Request for Quotation

RFQ NUMBER
 DEP13009

HUNT COAL U-5071-86
ADDENDUM #1

CHANGES TO SCOPE OF WORK AND BID SCHEDULE

OFFICE OF SPECIAL RECLAMATION	
WALL AND ENDWALL TYPICALS	
SCALE:	DRAWN BY:
DATE:	PROJECT

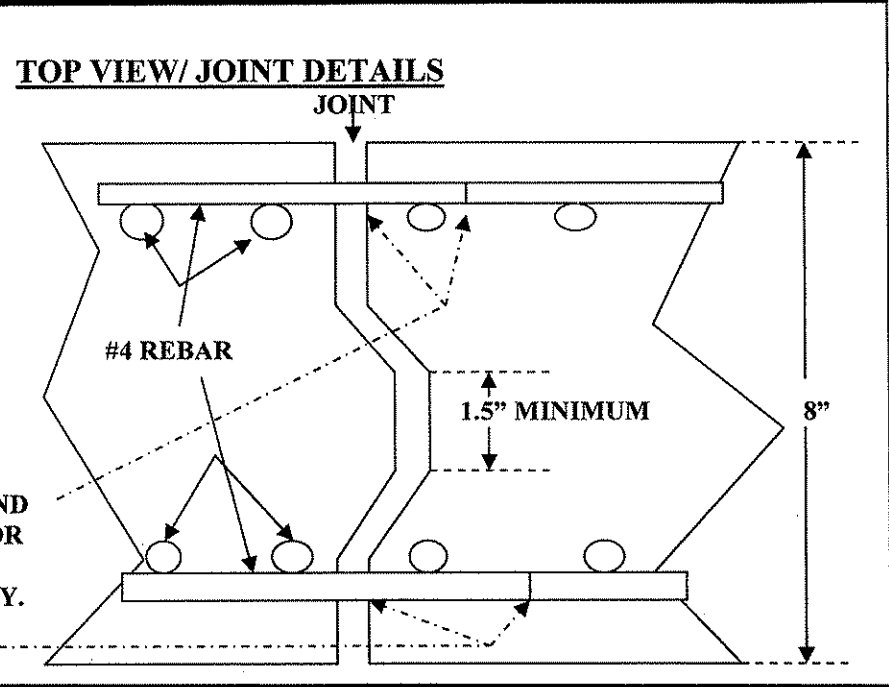
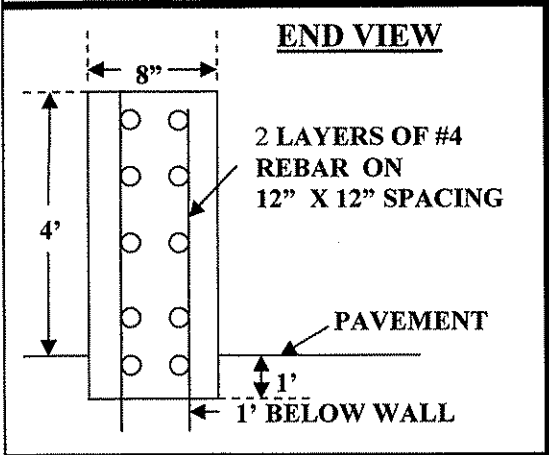
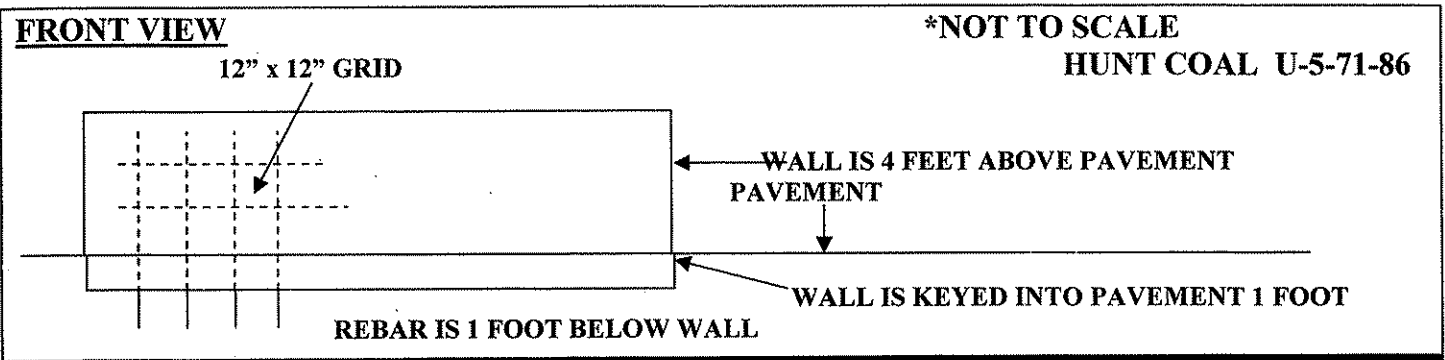
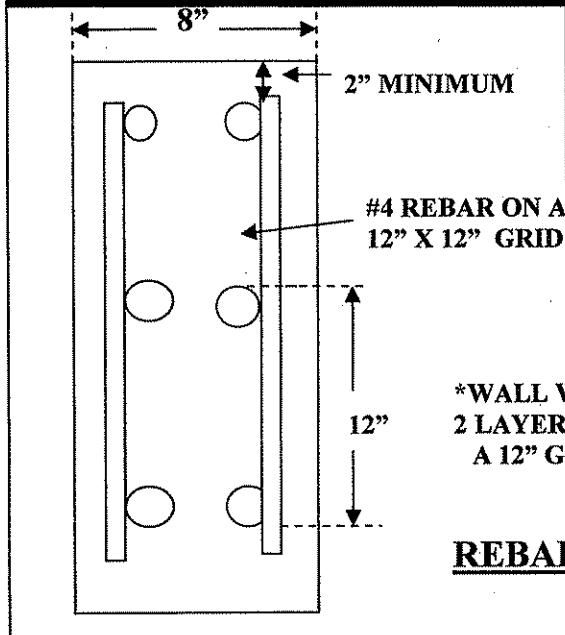
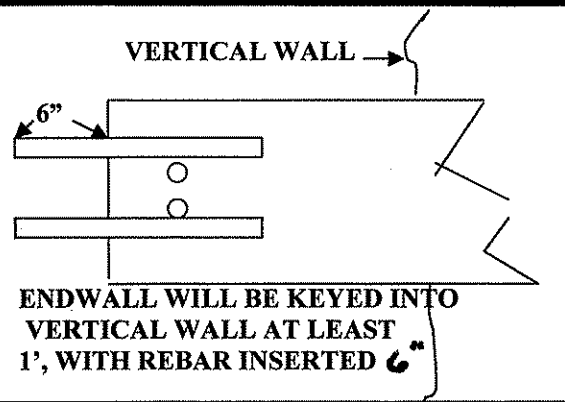
- 13) The typical on page 61, REBAR TYPICAL, is altered to show changes in rebar installation. (A new typical is attached.)
- 14) The typical, SEEP CUTOFF WALL, on page 62, is altered to show rebar will be on 12” centers instead of 8” centers. (A new typical is attached.)

*REBAR WILL EXTEND BEYOND END OF JOINT TO ALLOW FOR SPLICING OF REBAR AND TO PROVIDE REBAR CONTINUITY.

*WALL WILL HAVE 2 LAYERS OF #4 REBAR ON A 12" GRID.

OFFICE OF SPECIAL RECLAMATION	
GAS LINE UNDERPASS	
SCALE:	DRAWN BY:
DATE:	PROJECT NO:

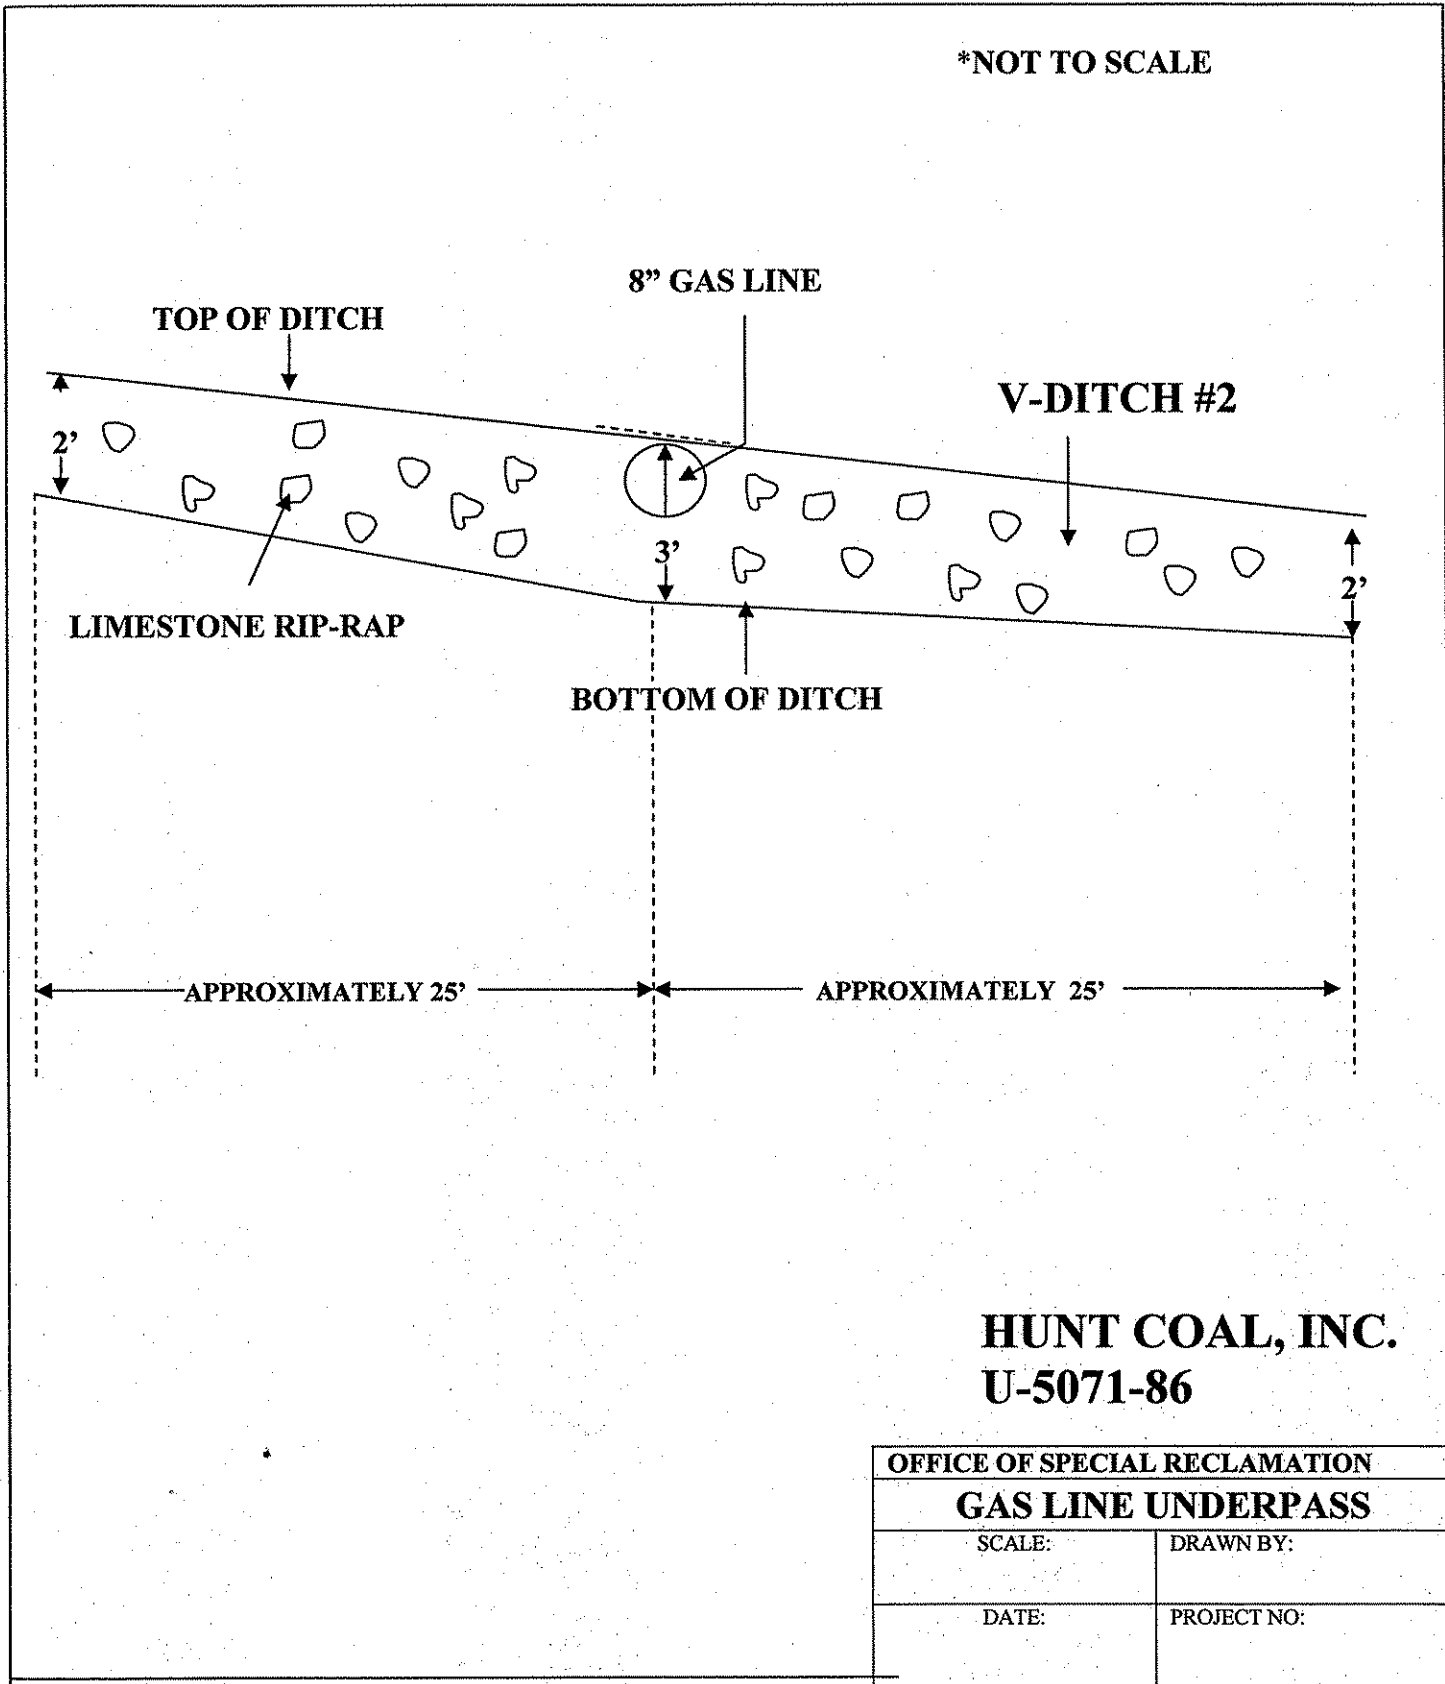
- 15) The typical, GAS LINE UNDERPASS, on page 67, is altered to show V-ditch #2 instead of V-ditch #1. (A new typical is attached.)
- 16) Change the typical “V-DITCH #1 GAS LINE CROSSING” on page 68 to read “V-DITCH #2 GAS LINE CROSSING.” Also the note at the bottom reads.....“*This 25’ section”...change to read “*This 50’ section will vary in depth to a maximum of 3’ deep at the pipe.” (A new typical is attached.)

OFFICE OF SPECIAL RECLAMATION	
STILLING BASIN	
SCALE:	DRAWN BY:
DATE:	PROJECT NO:

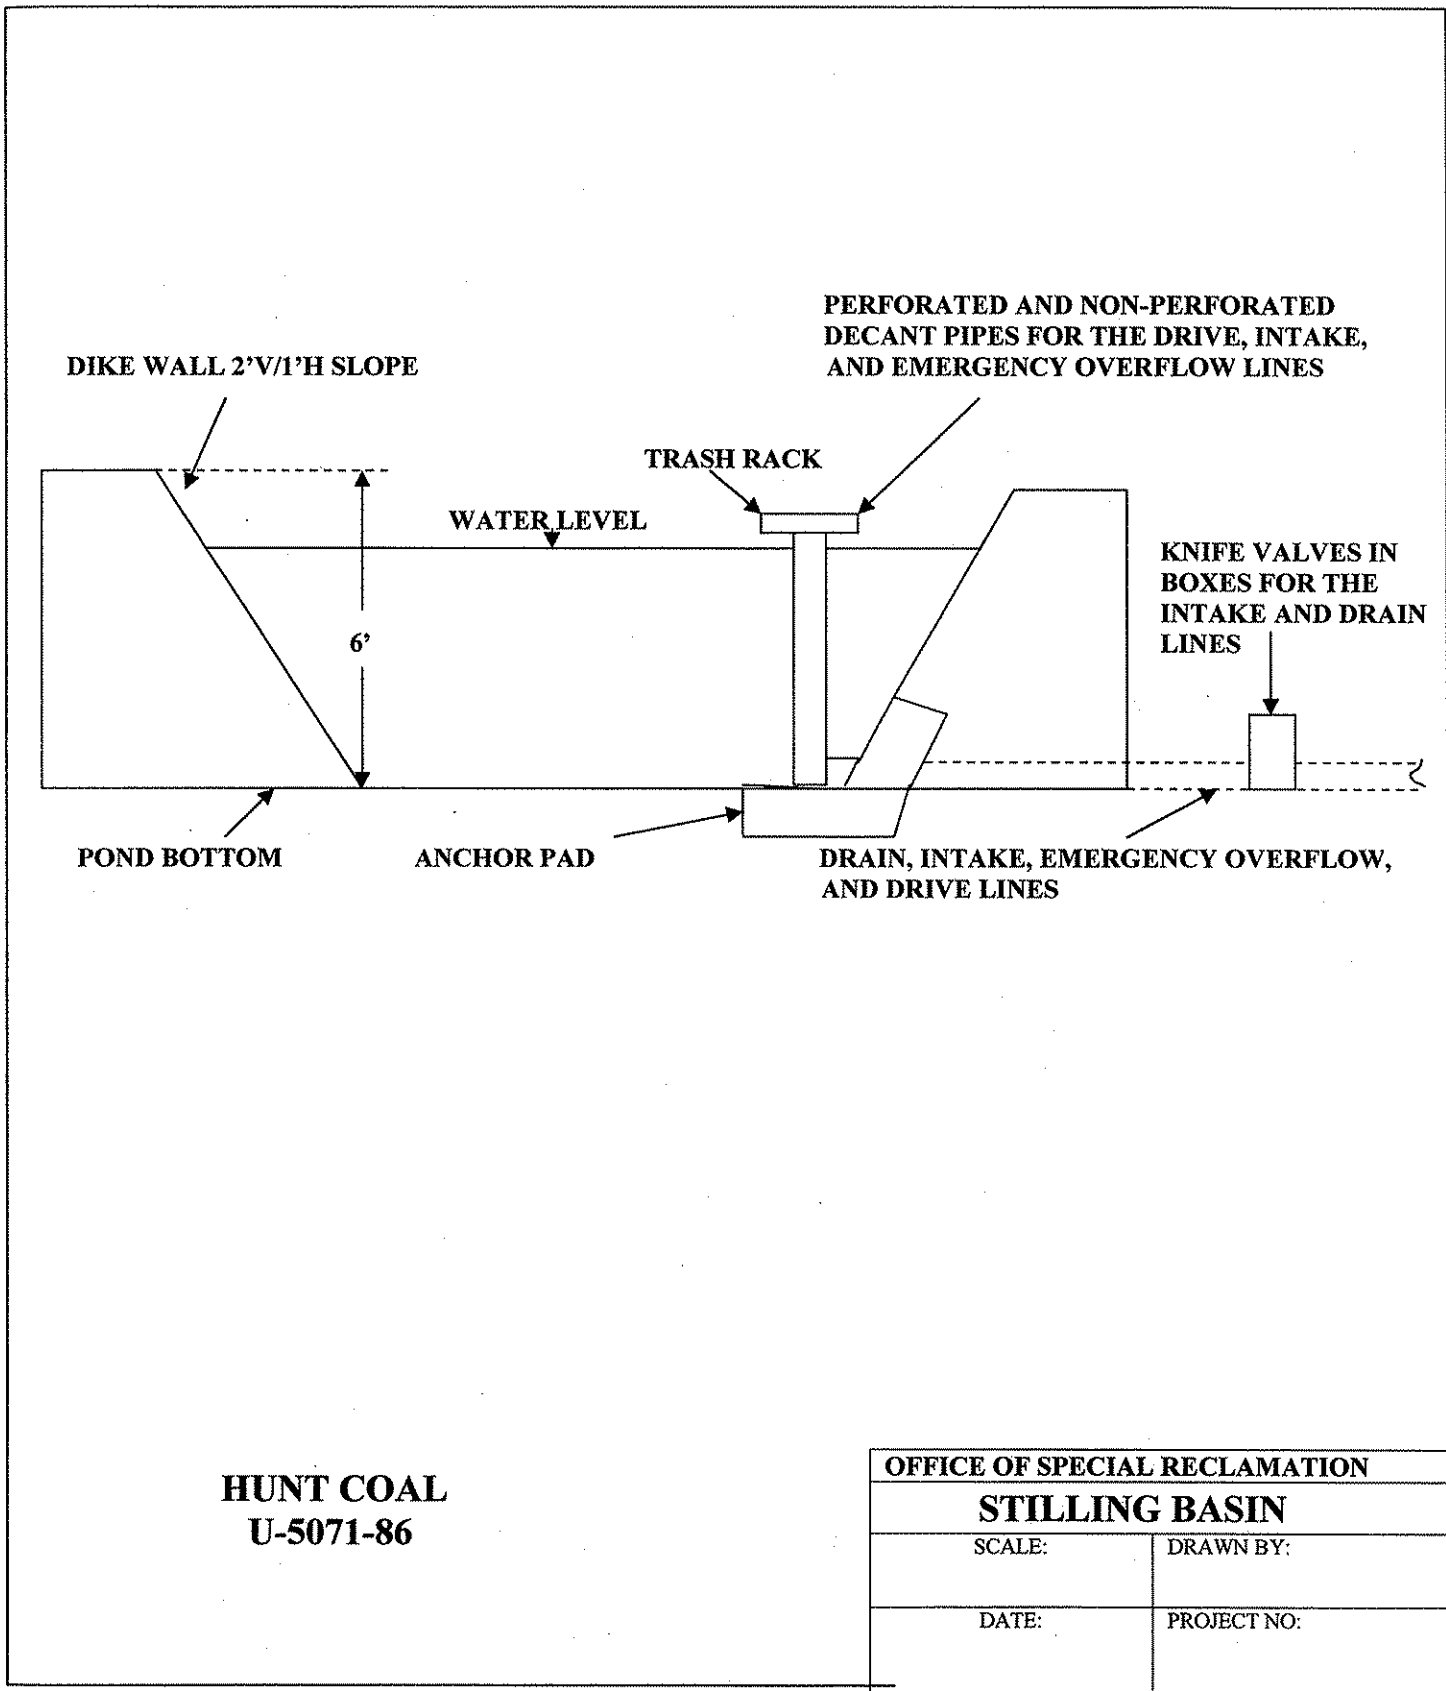
- 7) The typical,...“(STILLING BASIN/AQUA-FIX)... on page 69, will be changed to read ...“(STILLING BASIN)”. This typical, and the ones on page 70 (STILLING BASIN/TREATMENT UNIT), and on page 71 (DECANT PIPES/STILLING BASIN), were altered to reflect the changes in the scope, Item #12, page 14. Also, on page 70, typical STILLING BASIN/TREATMENT UNIT, change ...“V-DITCH #1” ...to ...“V-DITCH #2.” (New typicals are attached.)

- 17) On page 69, note the change in the typical regarding anchor pad design and pond bottom. (A new typical is attached.)
- 18) Change the typical, ROAD CULVERTS, on page 74, from... “24 “CMP CULVERTS”... to read ...“24” CULVERTS.” (A new typical is attached.)

OFFICE OF SPECIAL RECLAMATION	
60" ADS PIPE IN STREAM CHANNEL	
SCALE:	DRAWN BY:
DATE:	PROJECT NO:

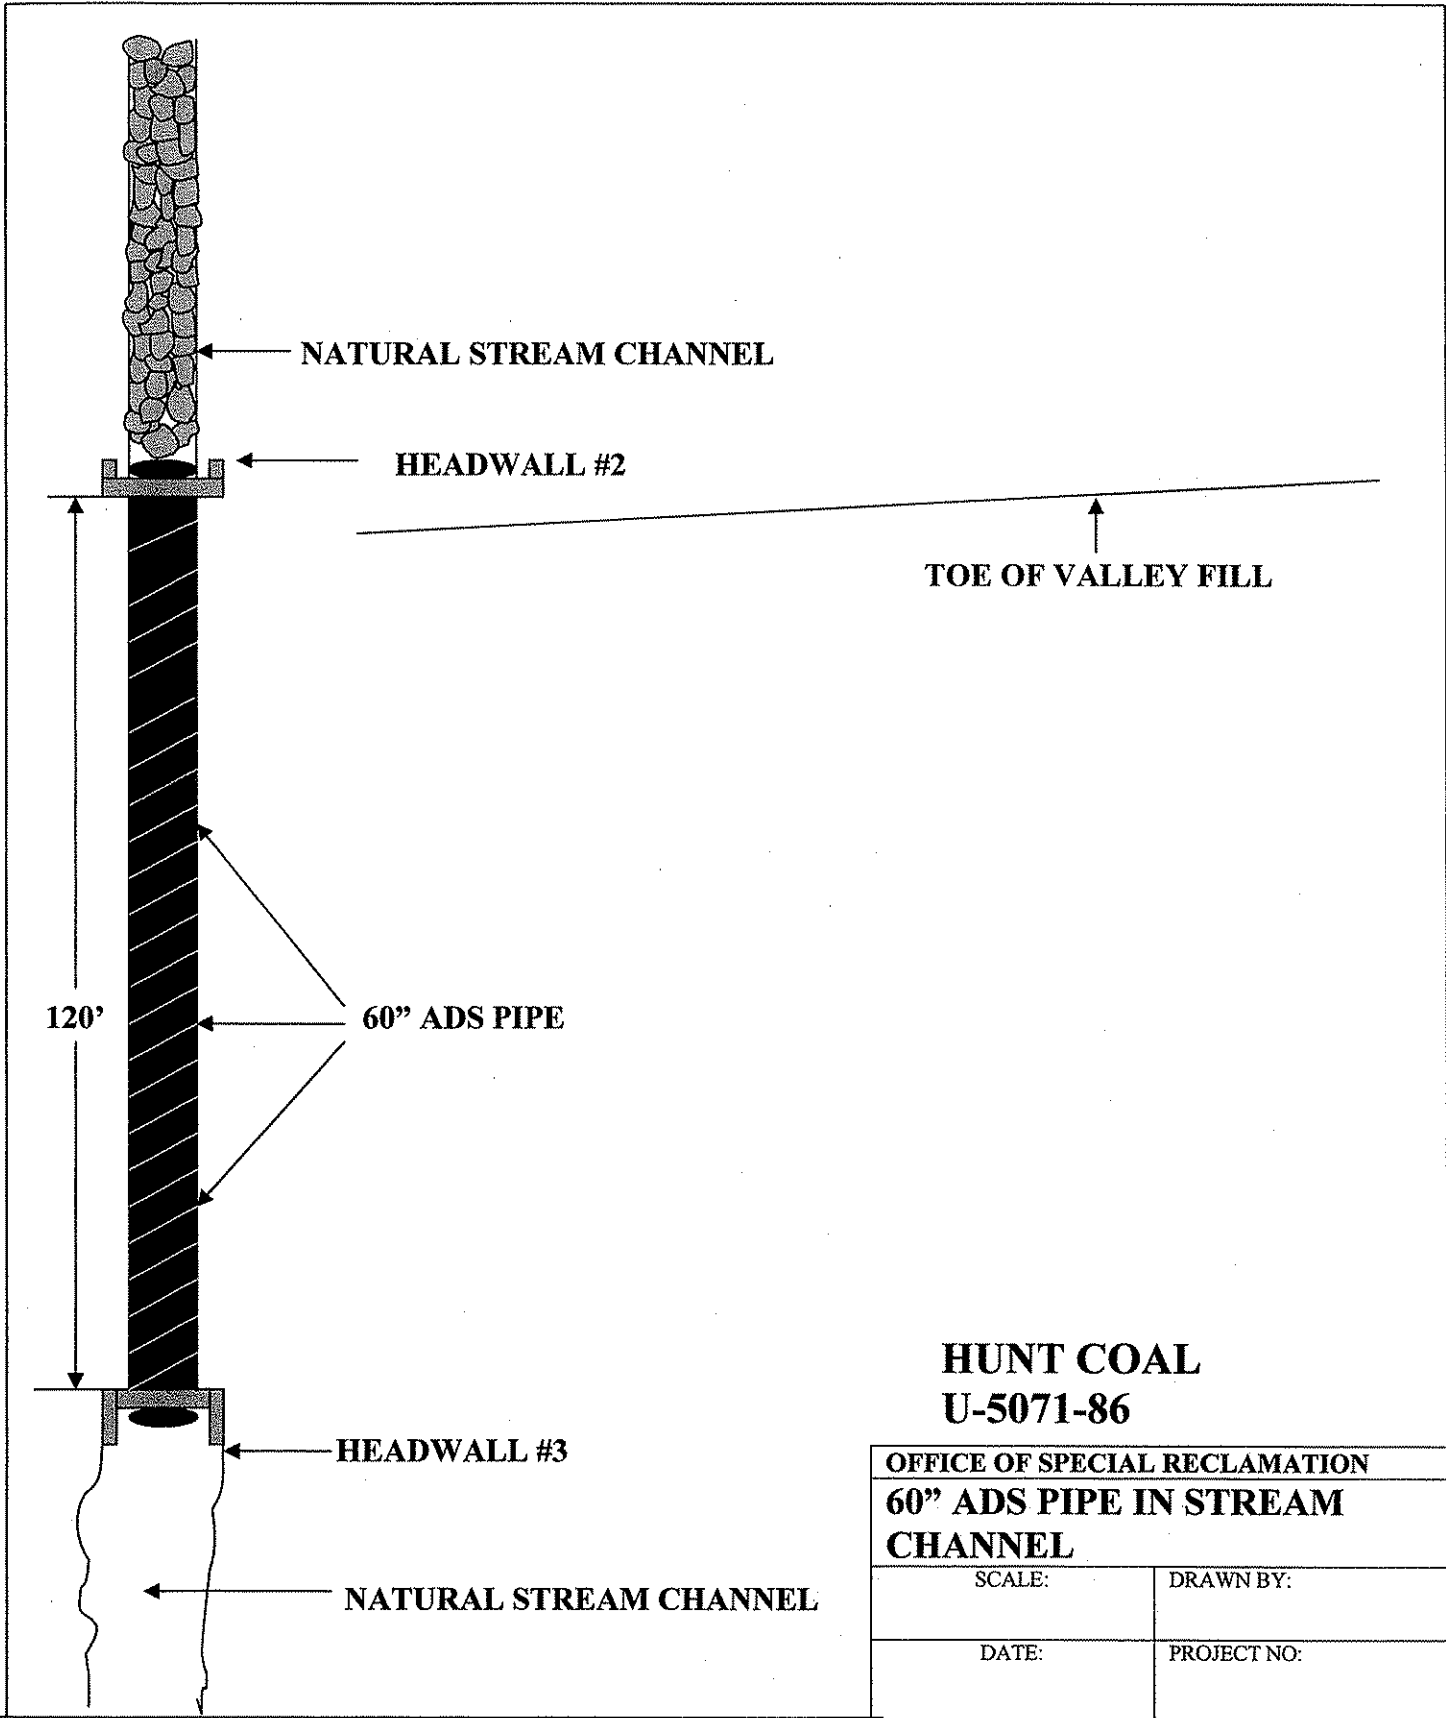
- 19) Change the typical name, CMP PIPE IN STREAM CHANNEL, on page 75, to read "60" ADS PIPE IN STREAM CHANNEL". Also change the length of the ADS pipe from 90' to 120'. (A new typical is attached.)

OFFICE OF SPECIAL RECLAMATION	
HEADWALLS #2 AND #3	
SCALE:	DRAWN BY:
DATE:	PROJECT NO:

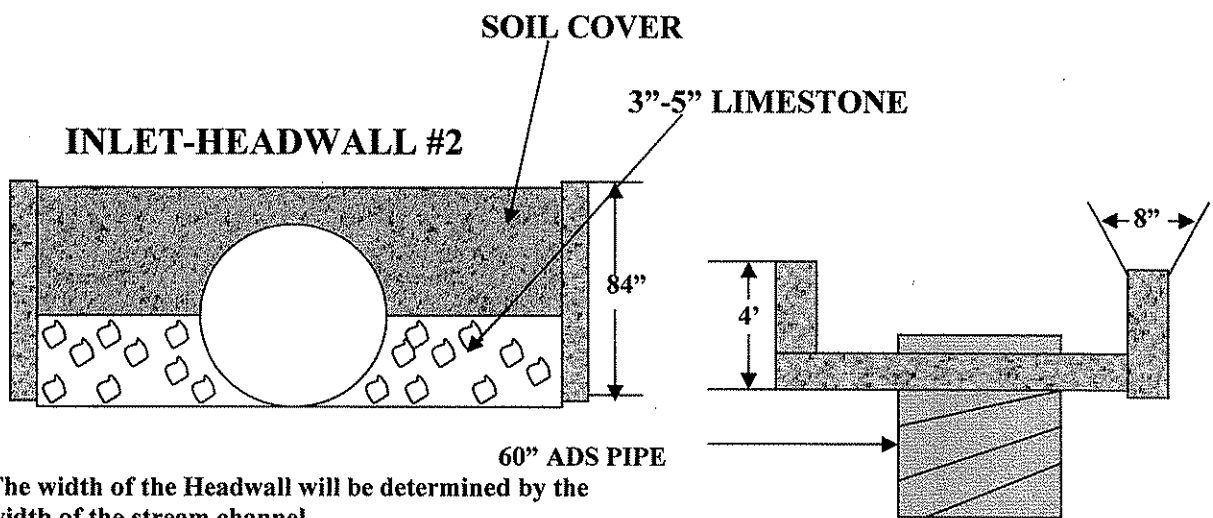
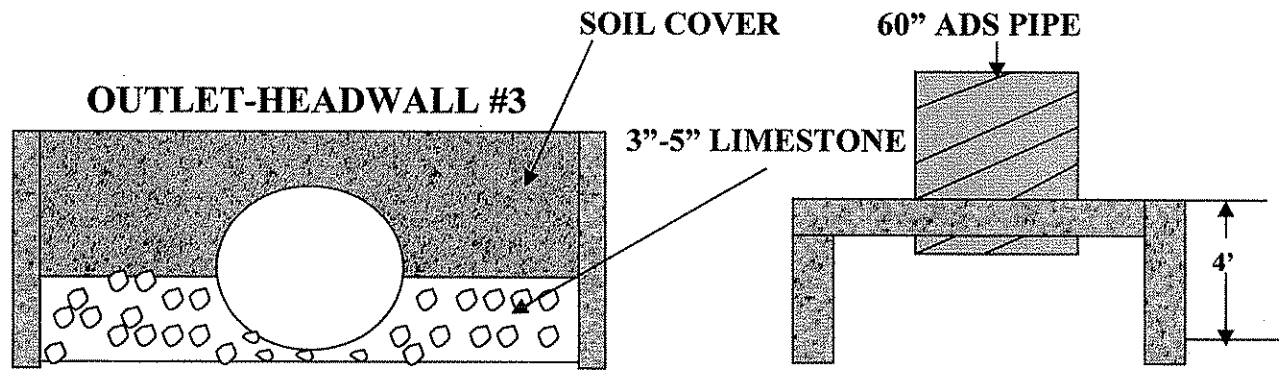
- 20) On the typical HEADWALL #2 AND #3, on page 76, change... "60" CMP PIPE"... to read ... "60" ADS PIPE." (A new typical is attached.)
- 21) On the typical SLUDGE DRYING CELL #3, page 81, change... "12" HDPE DR11 CONVEYANCE LINES"... to read... "6" HDPE DR17 CONVEYANCE LINES." Also change... "V-ditch #1"... to read... "V-ditch #2." (A new typical is attached.)
